Docket No. 52-004

SUBJECT: QUALITY OF SIMPLIFIED BOILING WATER REACTOR (SBWR) APPLICATION

QUALITY COMMENTS ON SBWR DOCUMENTS

Figure 5.2-5 Load Rejection with Bypass Failure — Pressure Scram (Continued)

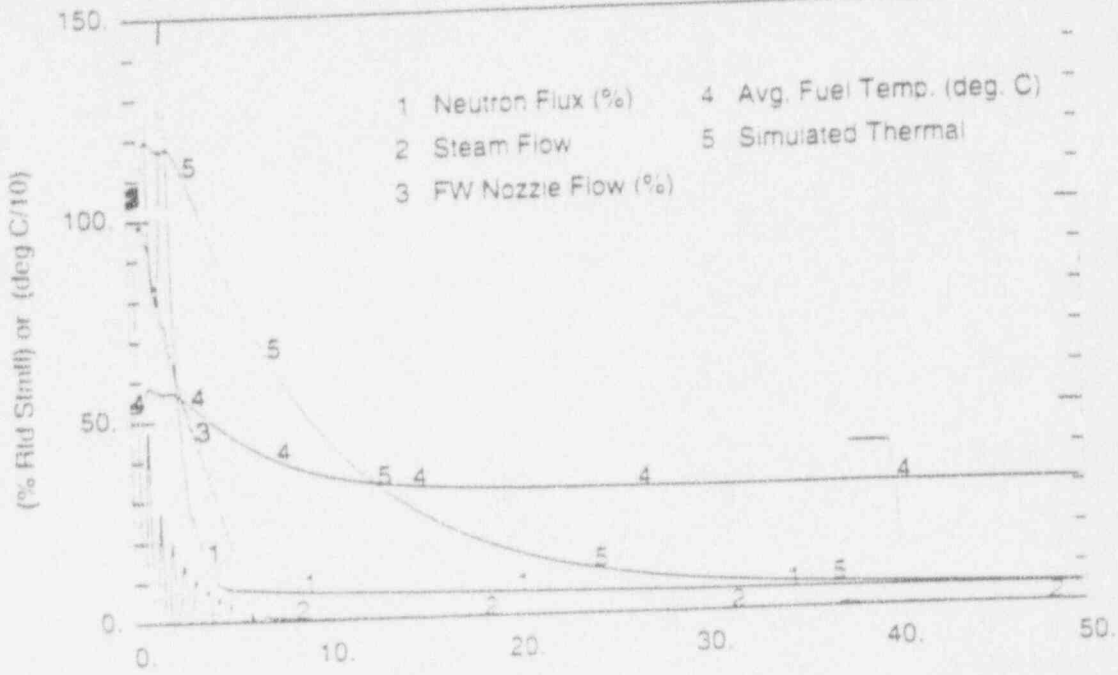
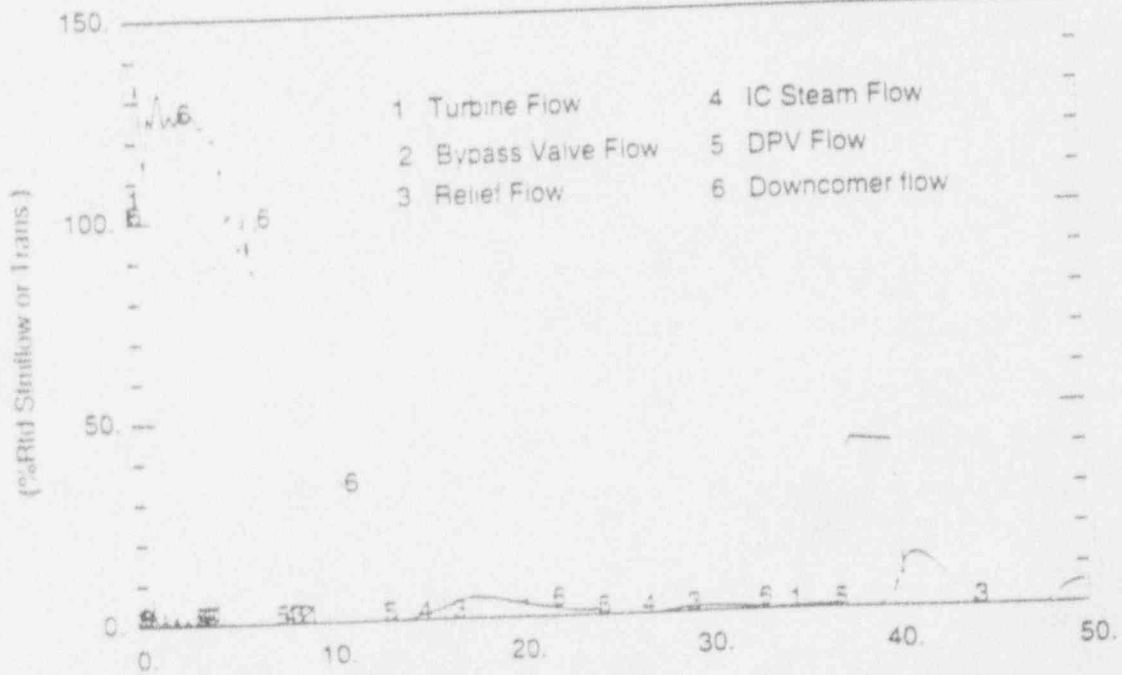
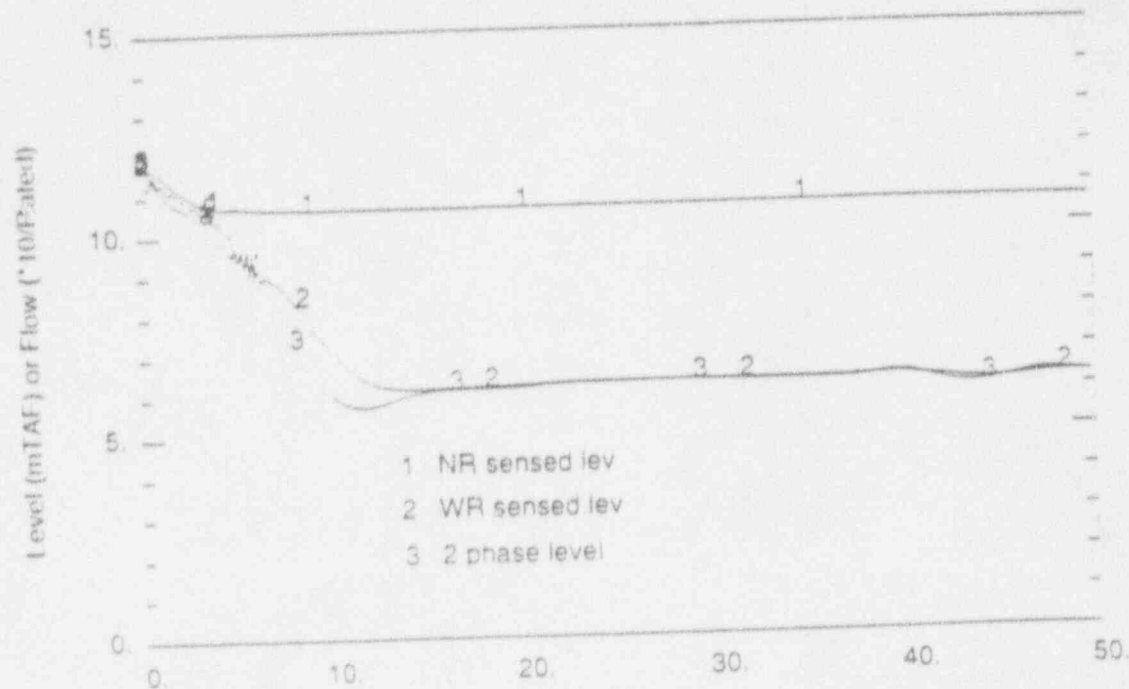
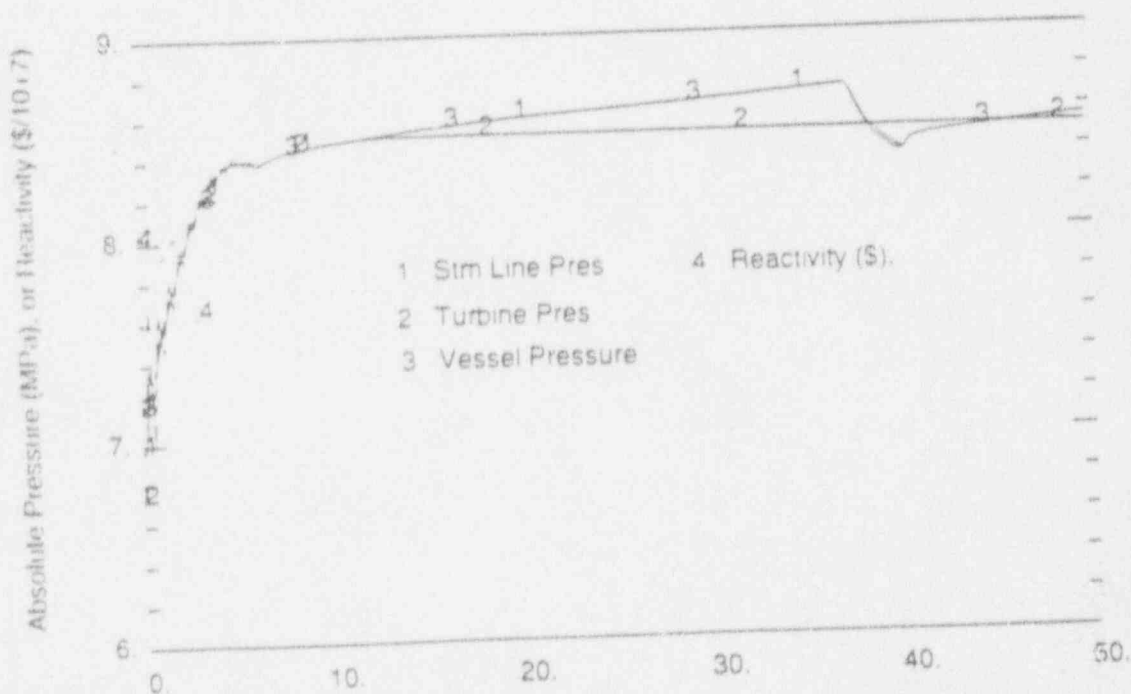
- (3) In SSAR Section 5.2.2, "Overpressure Protection," for the various parts of Figure 5.2-5, the x-coordinate values are not identified and parts of the figures are not readable (see the attached figures).
